January 27, 2017

Re: Follow up to the Risk Based Application Addendum and January 3, 2017 Meeting:
December 1, 2015 Application for Risk Based PCB Disposal Approval
450-490 South Avenue and 50 Center Street
Borough of Garwood
Block 401, Lots 1 and 2
Union County, New Jersey
NJDEP PI# 032470 and 631620

Additional Concrete Sampling Locations		
USEPA Risk-Based Plan Addendum Follow-Up 450 & 490 South Avenue and 50 Center Street Block 401, Lots 1 and 2 Garwood, New Jersey		
 EcolSciences, Inc. Environmental Management & Regulatory Compliance	January 2017 Scale: As Shown	Figure Number 2

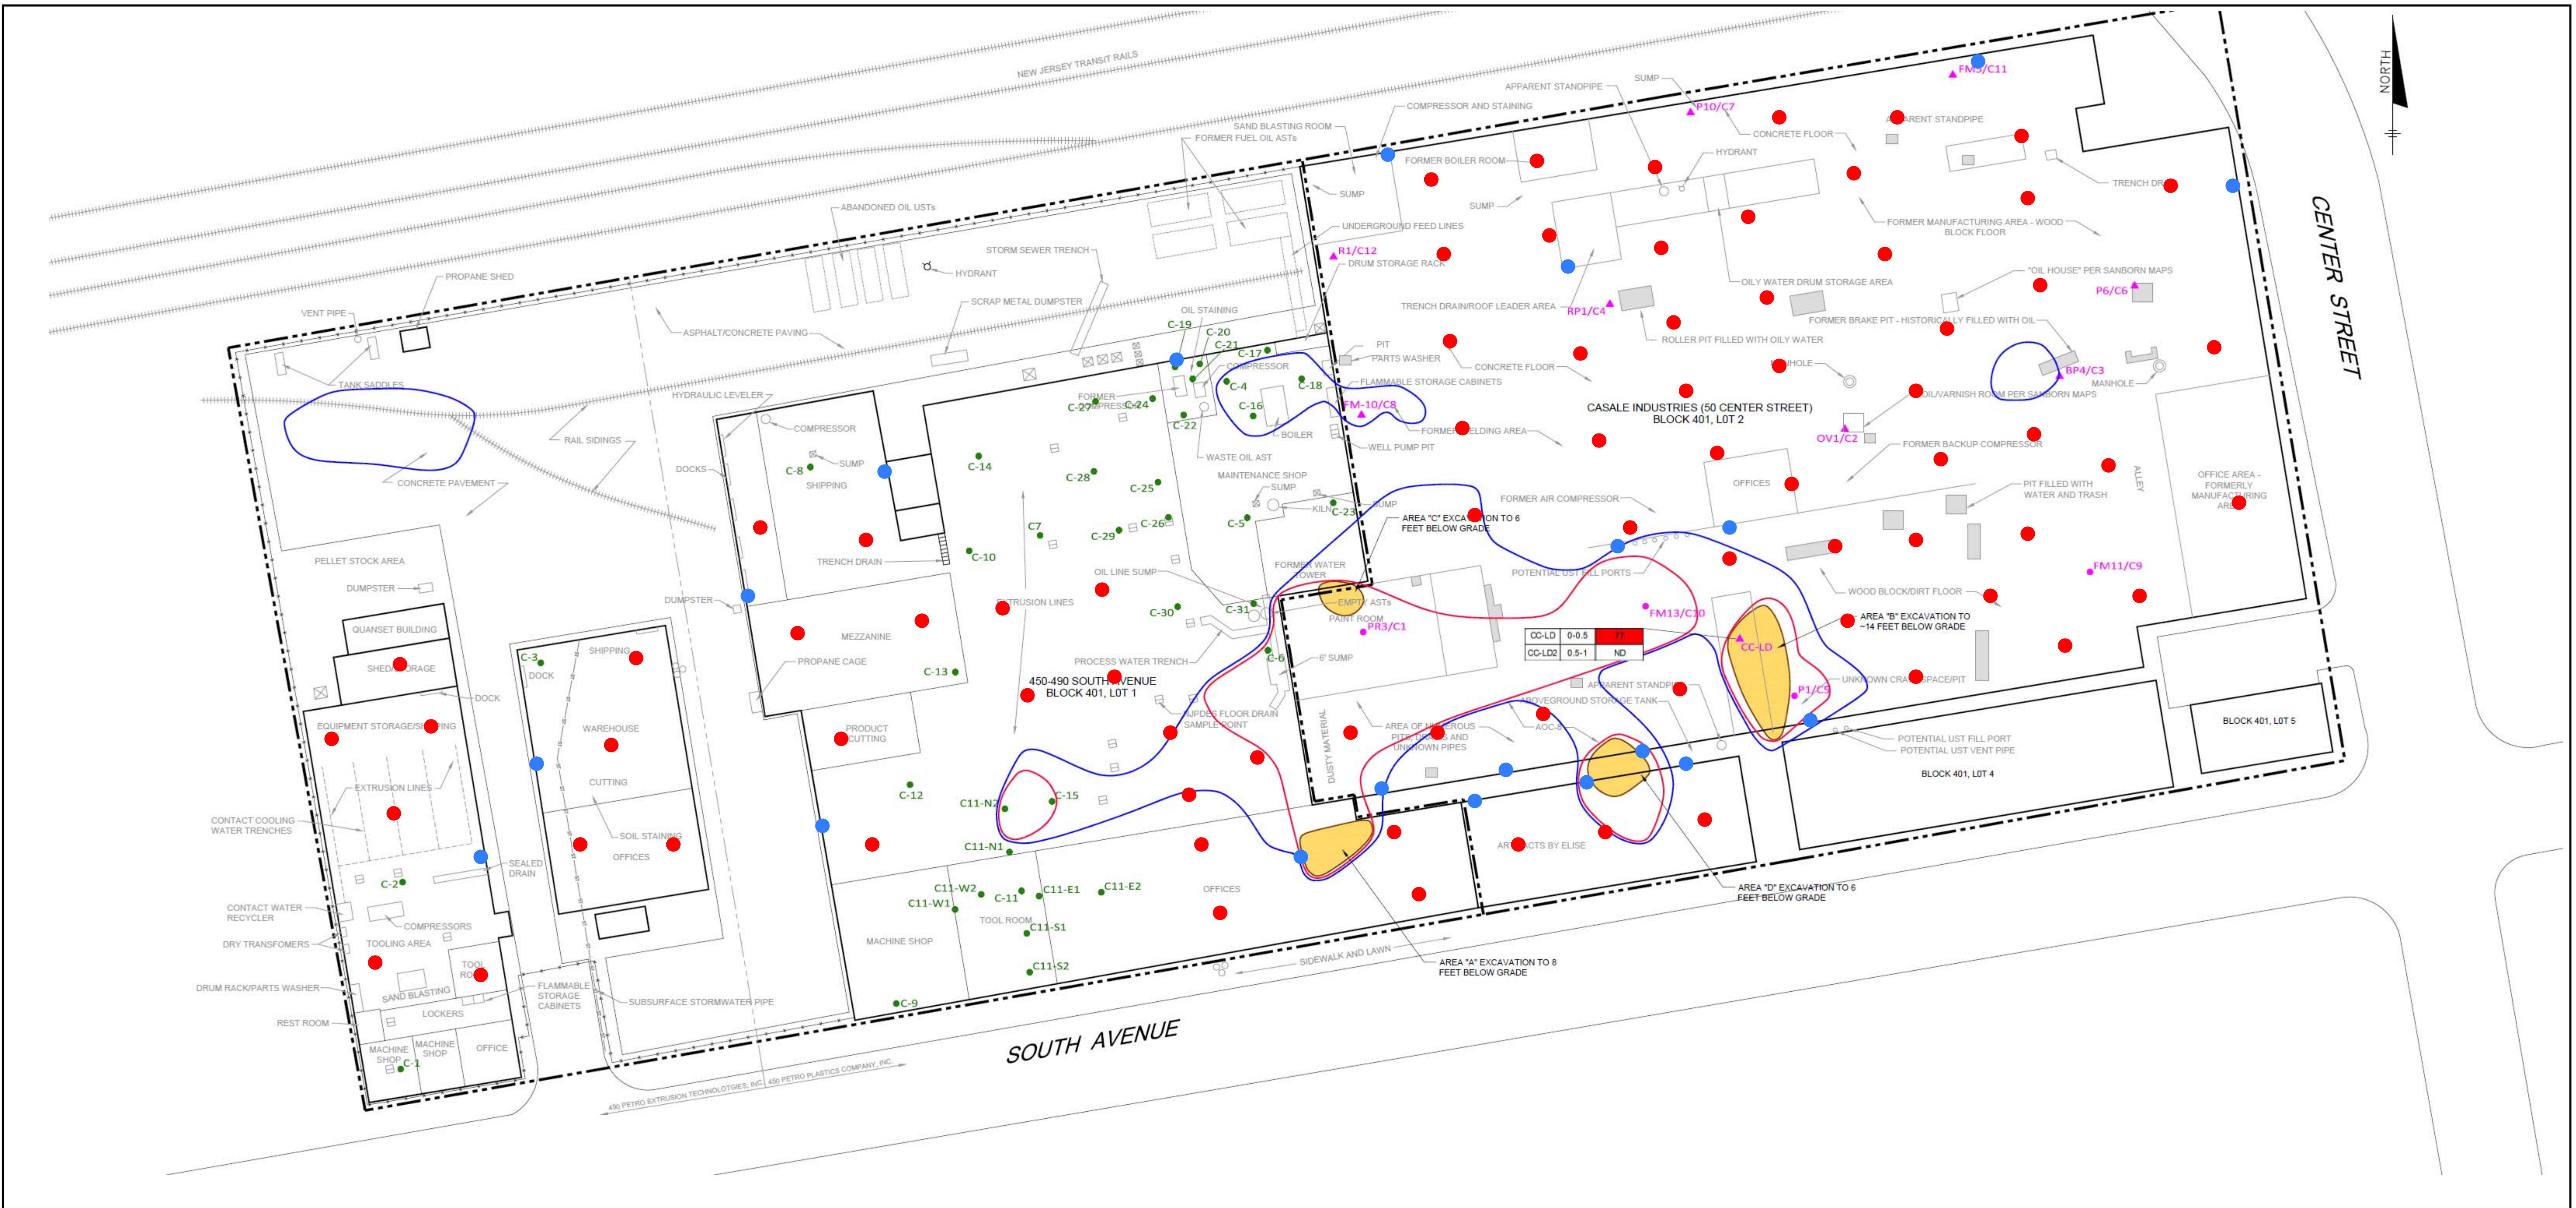
As discussed during the meeting, it is our understanding that the concrete slab sample rate of one sample for every 1,500-square feet of building slab is acceptable to the USEPA. Subsequent to approval of the Application but prior to demolition, concrete chip samples will be collected from locations evenly distributed throughout the buildings to comply with this frequency. A total of 77 additional concrete chip samples will be collected from the building slabs with 27 of these samples collected from the structures on Lot 1 and 50 of these samples collected from the concrete slab of the structures on Lot 2. The location of the building slab and wall sample locations discussed above is shown on the attached Figure 2. **This figure supersedes and replaces Figure 6 of our November 8, 2016 Addendum.**

Property Layout Plan

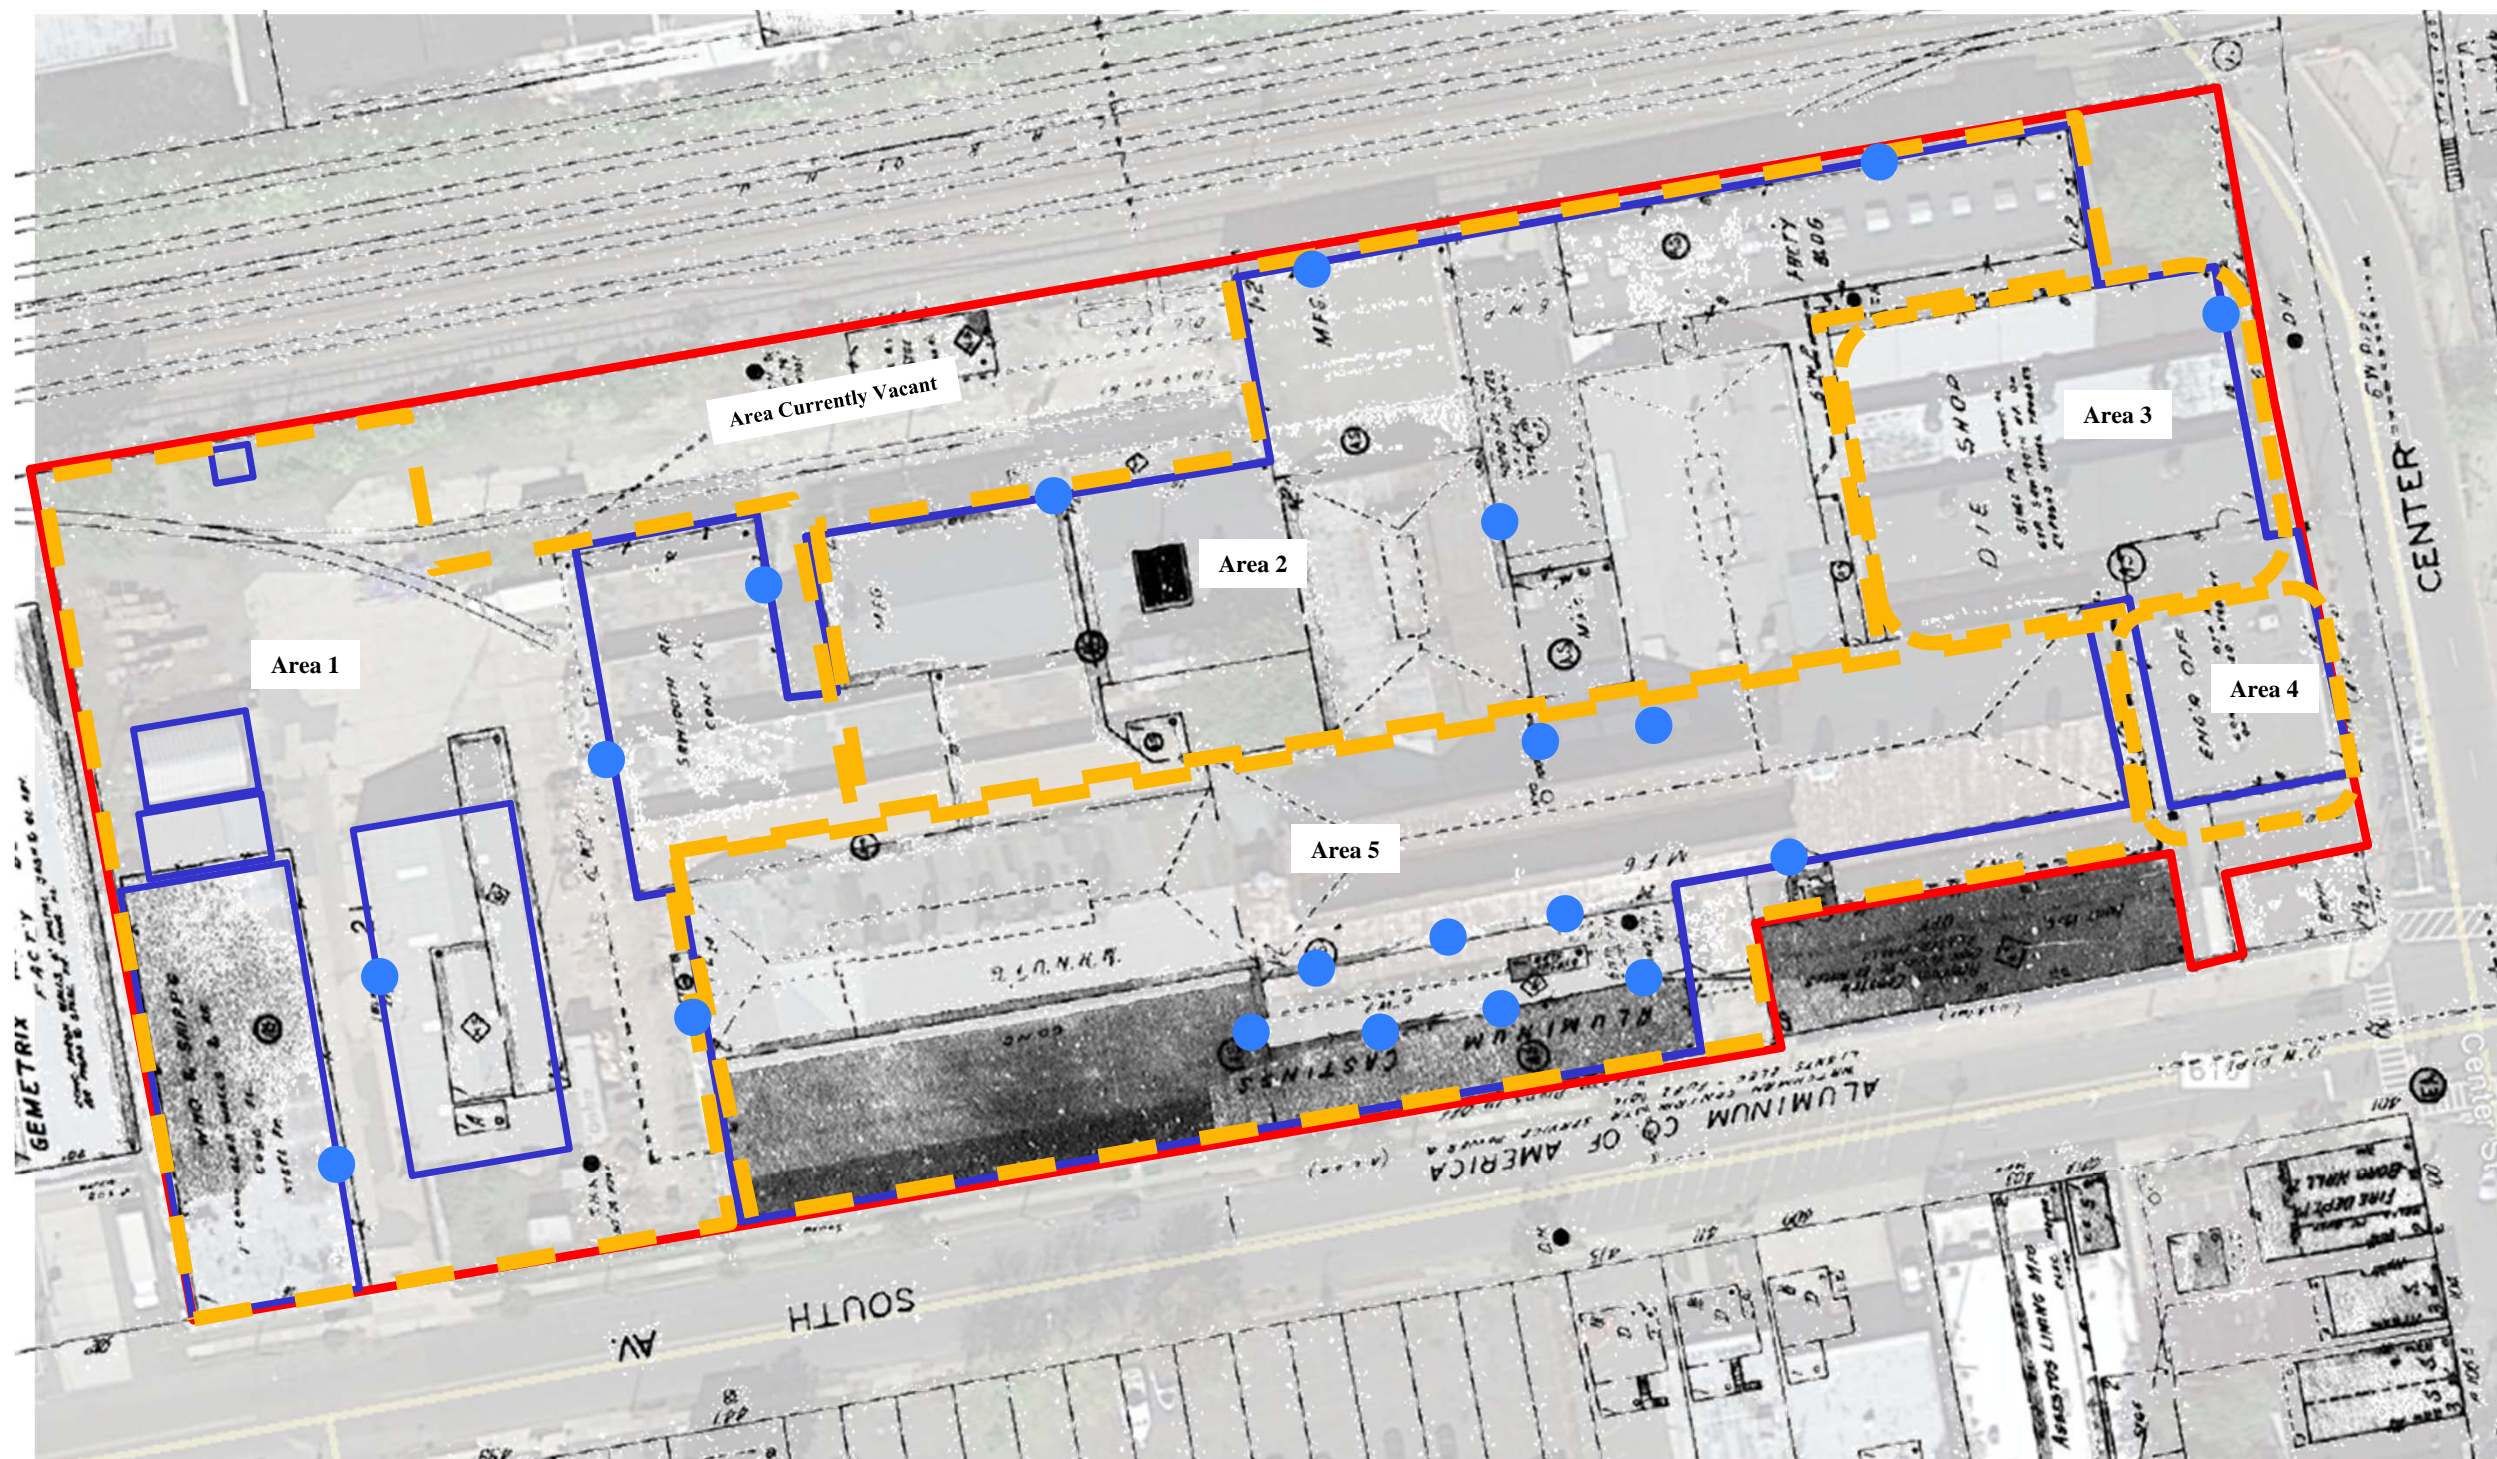
During our January 3, 2017 meeting, you requested additional information regarding the areas where PCBs were used onsite. The USEPA is requesting an increase in the proposed PCB concrete wall chip sample frequency in areas where PCBs may have been used inside the building.

For ease of discussion purposes, the site was divided into different sections as shown on Figure 1 which also presents the 1949 Sanborn Map overlaid on a current aerial image. The sections of the building are discussed below.

As discussed during the meeting, a total of ten concrete chip samples will be collected from the wall masonry through Areas 1 through 4 (non-PCB use areas).

Notwithstanding EcolSciences conceptual site model of the PCB discharges, since this area is the location where PCB containing materials were largely used, subsequent to the USEPA's approval of the Application (but prior to demolition) concrete chip samples will be collected from the walls in ten locations from this area of the building. Given the significant height of the ceiling in the area (generally greater than 20 feet), and that no ceiling staining was observed, the sampling will be limited to the walls. Upon receipt of the analytical results, the material will be handled accordingly in a manner consistent with that proposed in the application as follows:
